CITY OF PROVIDENCE, RHODE ISLAND

RFP Title: Site Improvements at Miguel Luna Park

Addendum #: 2

Issue Date: 04/11/2025

L-5.1

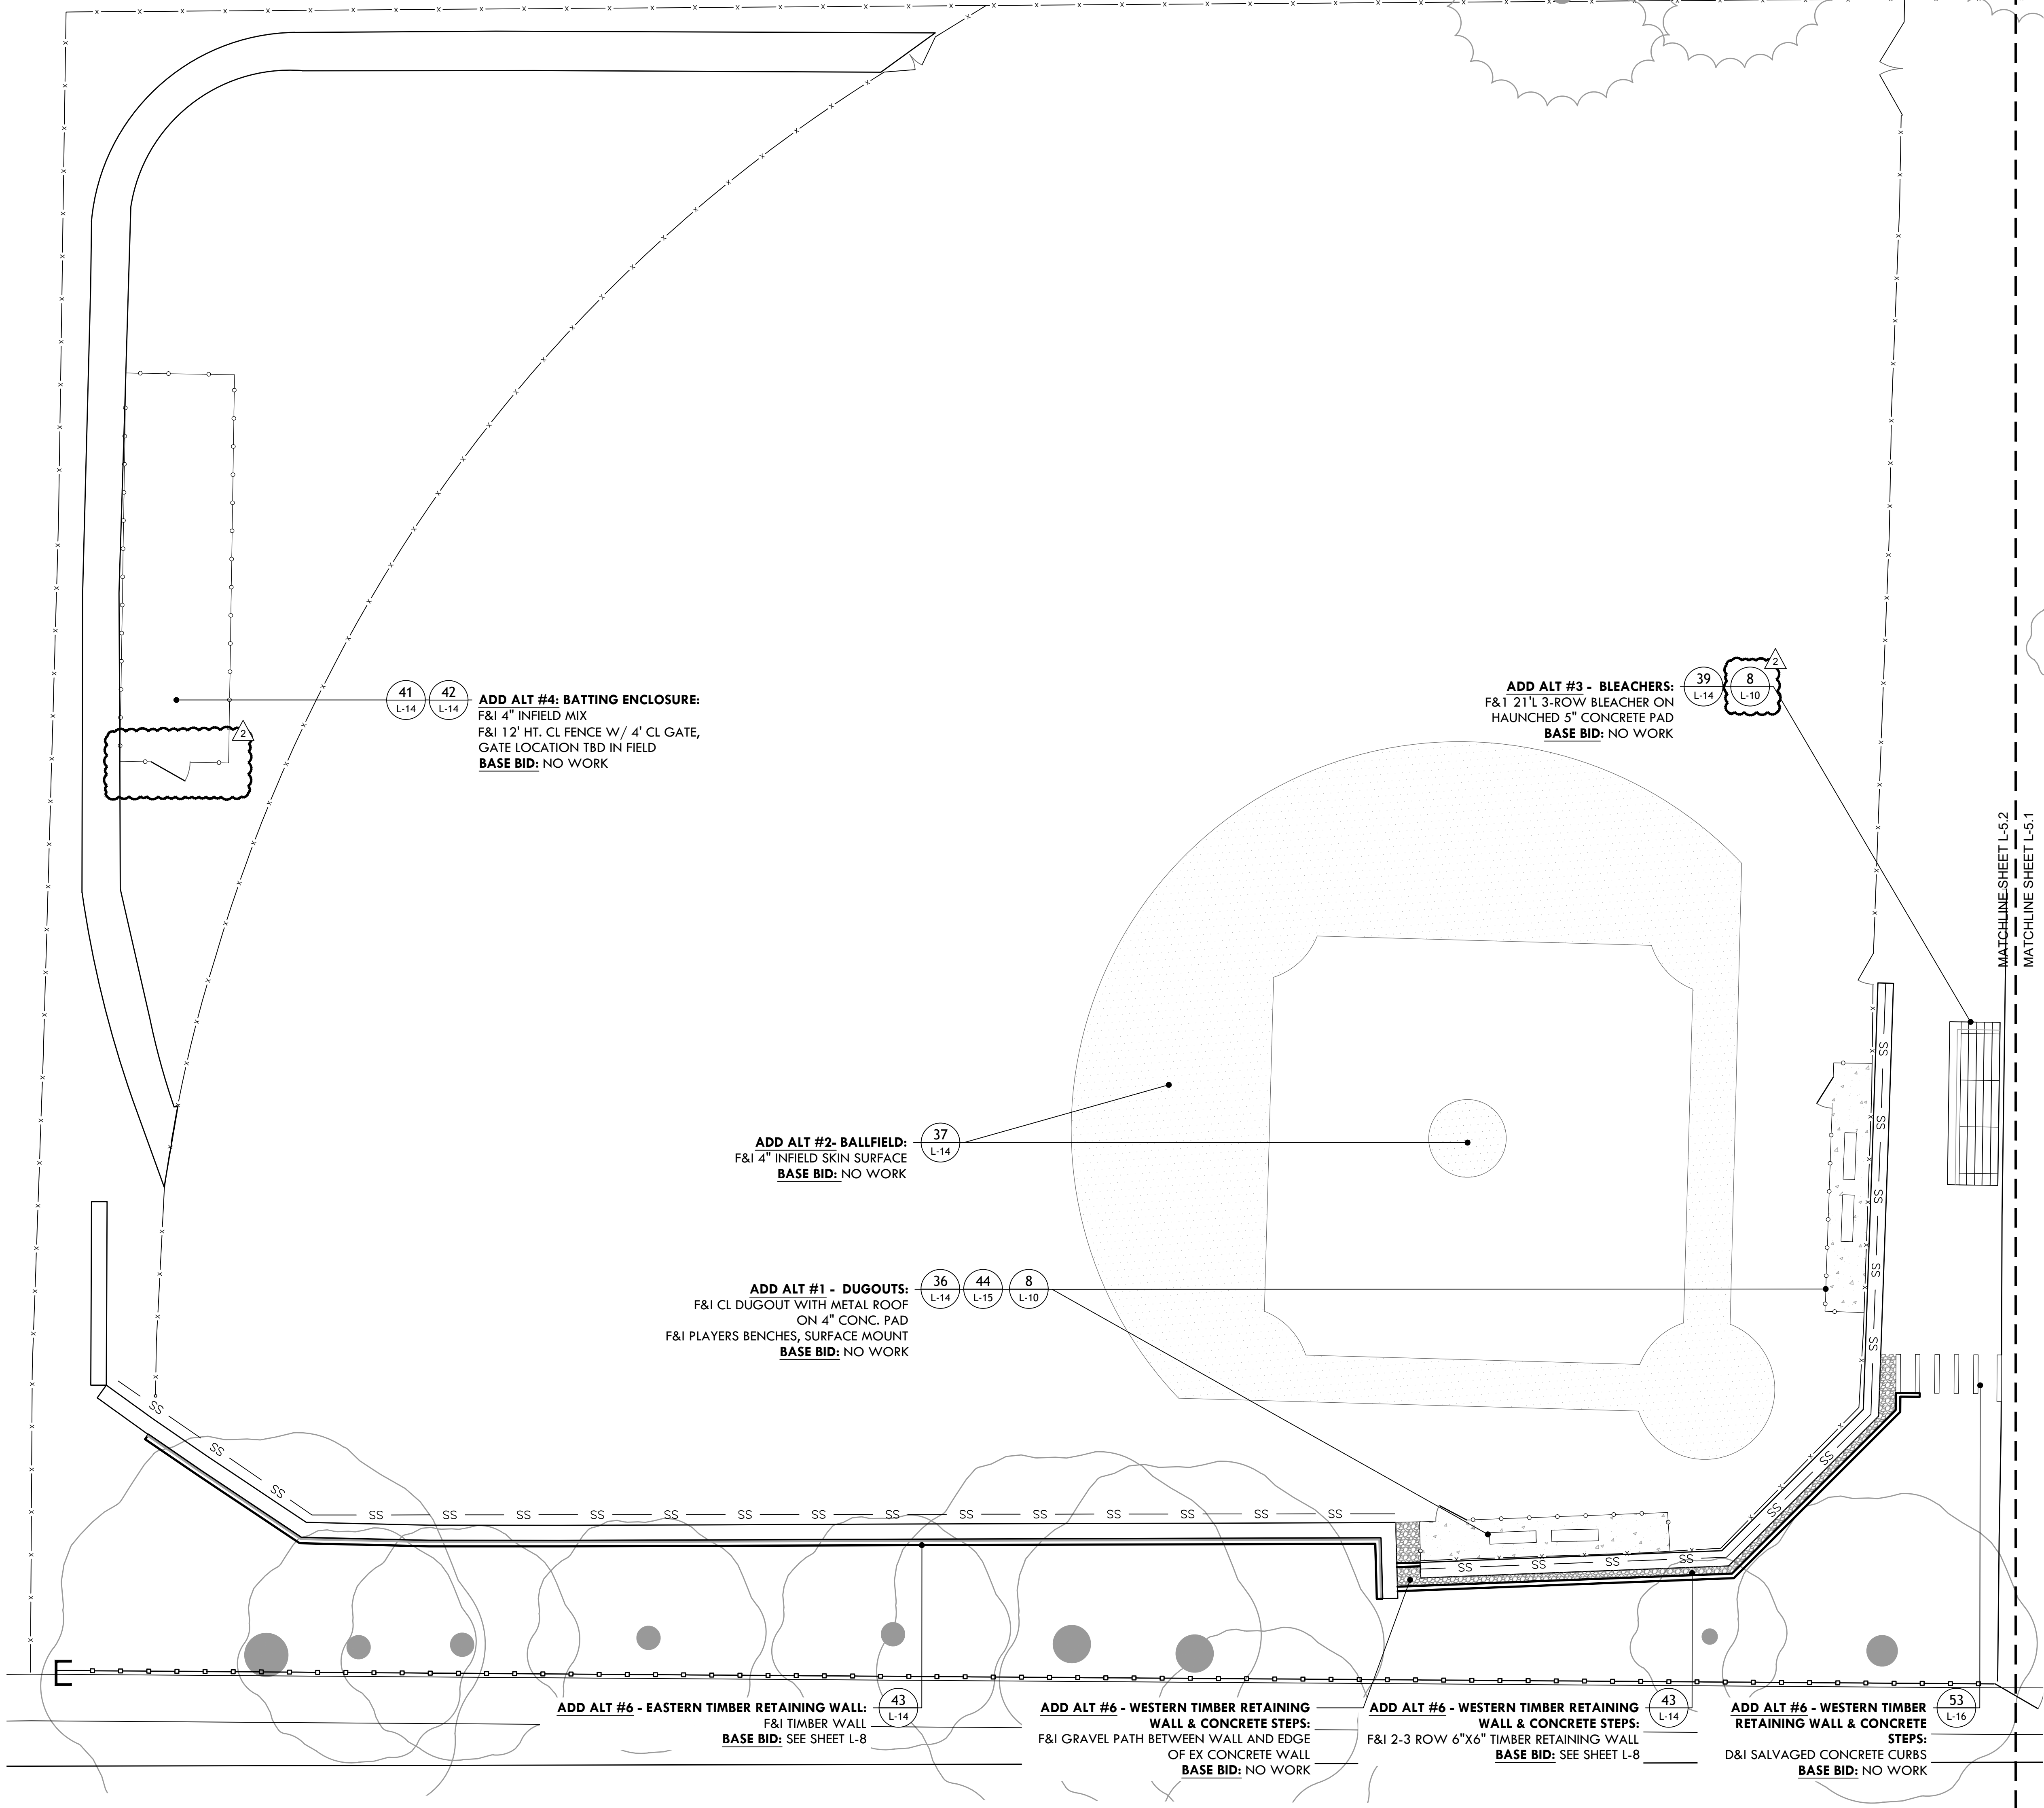
1. Q: Can you please advise/confirm the requested quantities for the site furnishings?
A: Please use information identified on Materials Plans L-5.1 and L-5.2 for quantities and types of furnishings.
2. Q: Is there any concern for the water meter enclosure being non-heated?
A: Water service is only turned on during the warm months when the irrigation, the splashpad and bathrooms are operated.
3. Q: How is the remaining water released from the water meter to prevent winter damage?
A: Water is turned off at the curb stop at the sidewalk.
4. Q: Are both waterlines entering the building?
A: The waterlines entering the building are the existing 1.5" line for bathroom use and the new 2" line designated for the splashpad. The existing 2" irrigation line is to remain as is.
